From: Katie Jones [kjones@riceswd.com]
Sent: Monday, January 23, 2012 10:40 AM
To: Hansen, Edward J., EMNRD
Cc: Hack Conder; L Peter Galusky; Laura Pena
Subject: BD N-18 BGT (1R-500) CAP Addendum
Attachments: BD N-18 BGT - spoil pile lab.pdf; BD N-18 BGT excavating to 30 ft, facing NW 1.17.12.JPG

The following is an Addendum to the BD N-18 BGT (1R-500) Corrective Action Plan (CAP) submitted to the NMOCD on July 1, 2011 and approved on July 13, 2011.

Re: Rice Operating Company
Site Summary and Corrective Action Plan
BD N-18 Below Grade Tanks
UL-N, Sec 18, T22S, R37E
NMOCD Case No. 1R-500

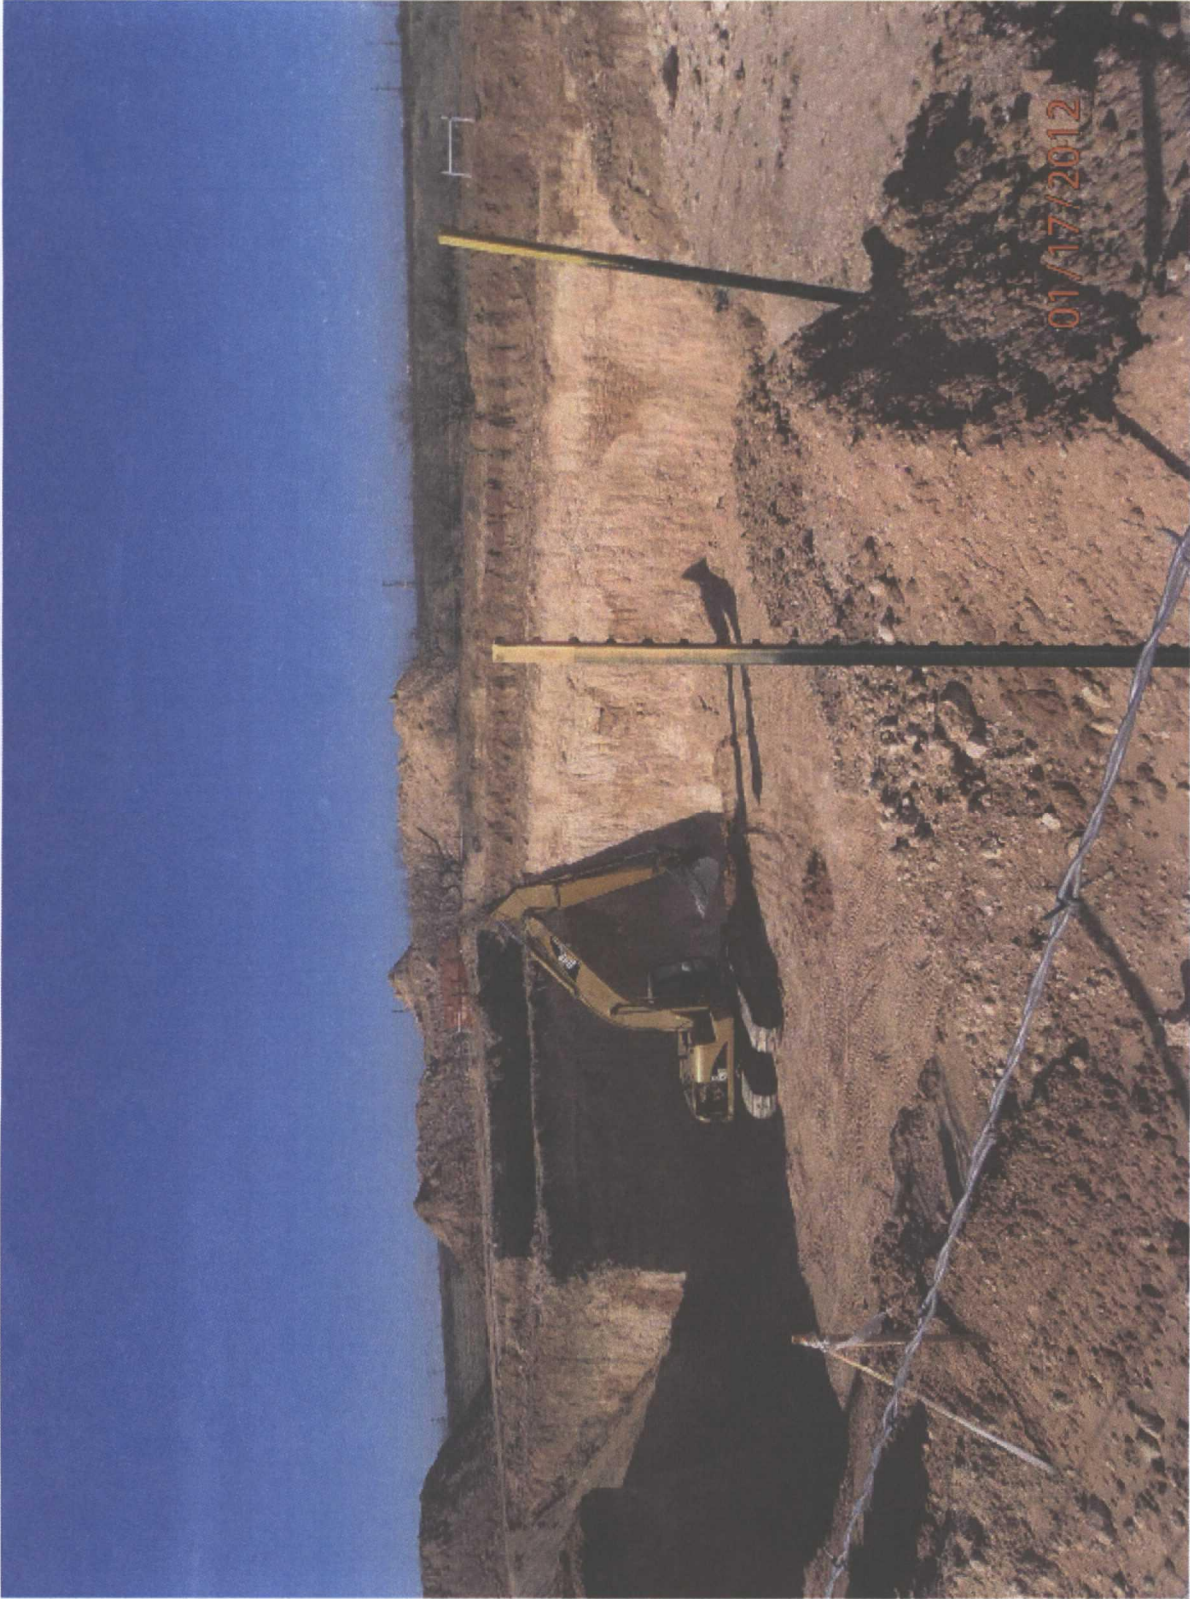
The site has been excavated to dimensions of 98x98 ft to a depth of 27 ft below ground surface (bgs) with a 4-5 ft deep shelf extending 5 ft north, south, east, and west. Personnel began excavating the site to 30 ft bgs, and an unexpected rock layer was encountered making excavating almost impossible. An area of approximately 15x15 ft required almost 4 days of field work to reach the depth of 30 ft bgs. A photograph showing progress as of January 17, 2012 is attached. Excavated soil has also yielded unexpectedly low chloride concentrations that meet backfill requirements, as approved by the NMOCD. A composite sample from each of the four spoil piles was analyzed by Cardinal Laboratories and yielded concentrations of 304 mg/kg, 608 mg/kg, 352 mg/kg, and 464 mg/kg (lab analysis is attached). A bottom composite sample was also field titrated this morning, January 23, 2012, and yielded a chloride concentration of 855 mg/kg. Based on the unexpected rock layer and the lower concentrations of chloride encountered at depth, ROC proposes installing the synthetic liner at 27 ft bgs as noted in the following Addendum to the NMOCD approved CAP.

Page 3, paragraph 1: *Vadose (unsaturated) Zone Remedy*; red lettering will be deleted from the paragraph and blue lettering will be added to the paragraph.

"Although Multi-Med modeling indicates that residual, contributed soil chlorides do not pose a threat to groundwater quality without any remedy, we nevertheless propose to install a synthetic double liner system across the former tank area to preclude any possibility of potential future groundwater impacts (Figure 3). The bottom liner will be installed at an approximate depth of ~~30~~27 ft bgs and encompass an area of approximately 98 ft by 98 ft. Excavated soil material having a chloride concentration less than 2,000 mg/kg chloride and 100 PID (petroleum hydrocarbons) will be placed on top of this lower liner. The upper liner will be installed approximately 4 to 5 ft bgs and encompass an area of approximately 108 ft by 108 ft. Soil material having a chloride concentration of less than 500 mg/kg and 100 PID will be placed on top of the upper liner and graded to the natural ground contour. Excavated soil will be evaluated for use as backfill and any soil requiring disposal will be properly disposed of at a NMOCD approved facility. The ground surface above the liner system will be covered with caliche as the site will remain part of an active and operating SWD system."

Figure 3 – BD N-18 BGT proposed liners in relation to monitor wells and soil borings.

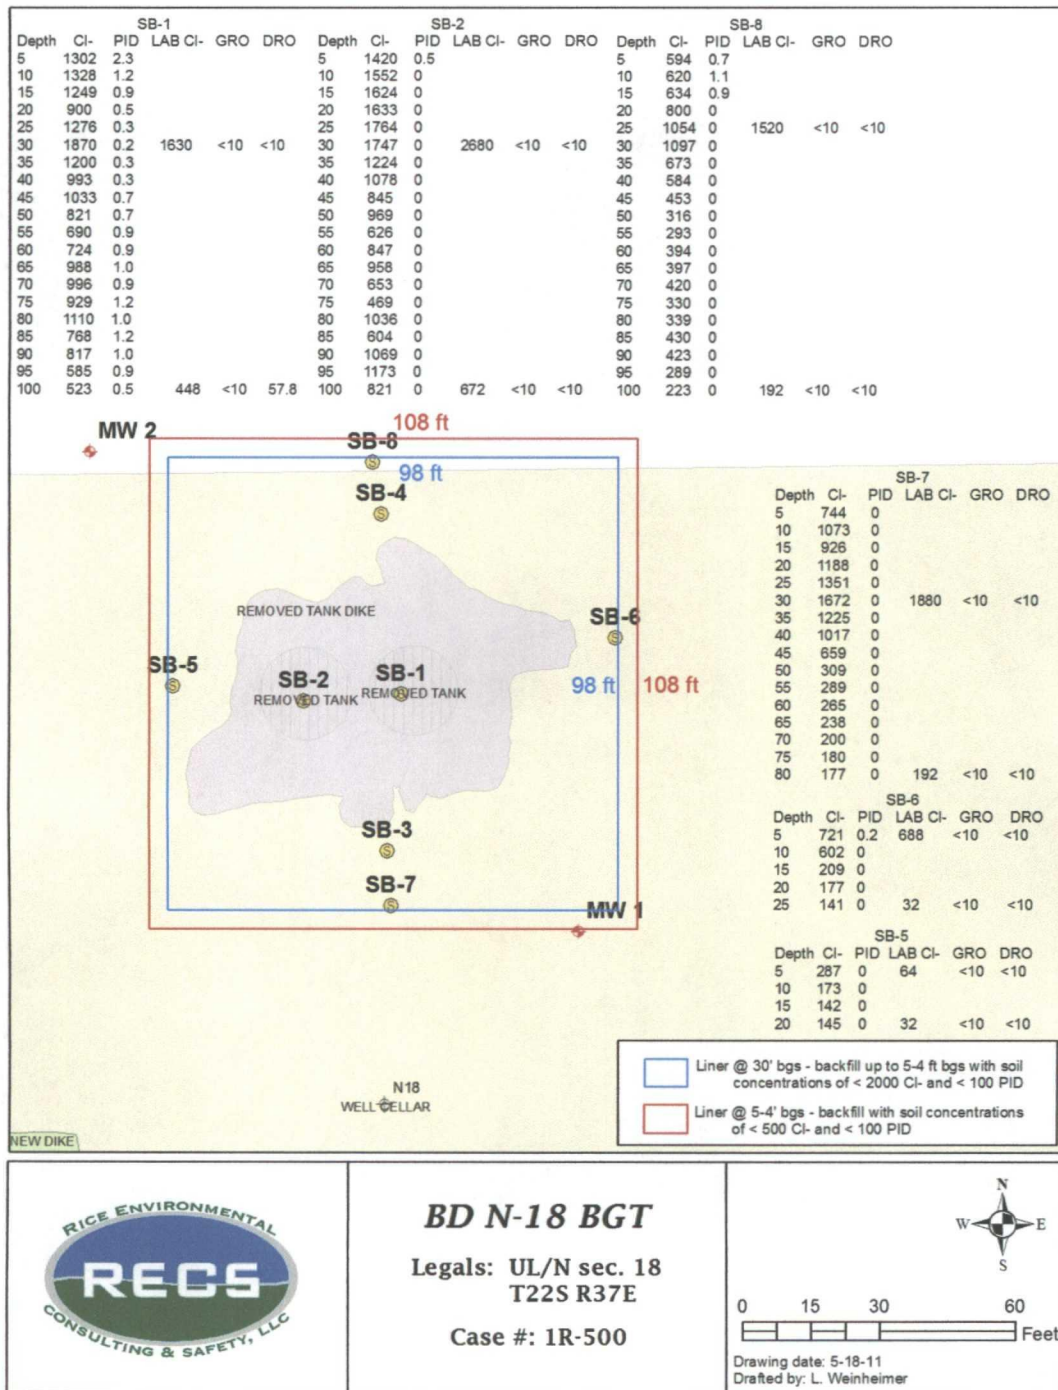
Although Multi-Med modeling indicates that residual, contributed soil chlorides do not pose a threat to groundwater quality without any remedy, we nevertheless propose to install a synthetic double-liner system across the former tank area to preclude any possibility of potential future groundwater impacts (Figure 3). The bottom liner will be installed at an approximate depth of 30 ft bgs and encompass an area of approximately 98 ft by 98 ft. Excavated soil material having a chloride concentration less than 2,000 mg/kg chloride and 100 PID (petroleum hydrocarbons) will be placed on top of this lower liner. The upper liner will be installed approximately 4 to 5 ft bgs and encompass an area of approximately 108 ft by 108 ft. Soil material having a chloride concentration of less than 500 mg/kg and 100 PID will be placed on top of the upper liner and graded to the natural ground contour. Excavated soil will be evaluated for use as backfill and any soil requiring disposal will be properly disposed of at a NMOCD approved facility. The ground surface above the liner system will be covered with caliche as the site will remain part of an active and operating SWD system.
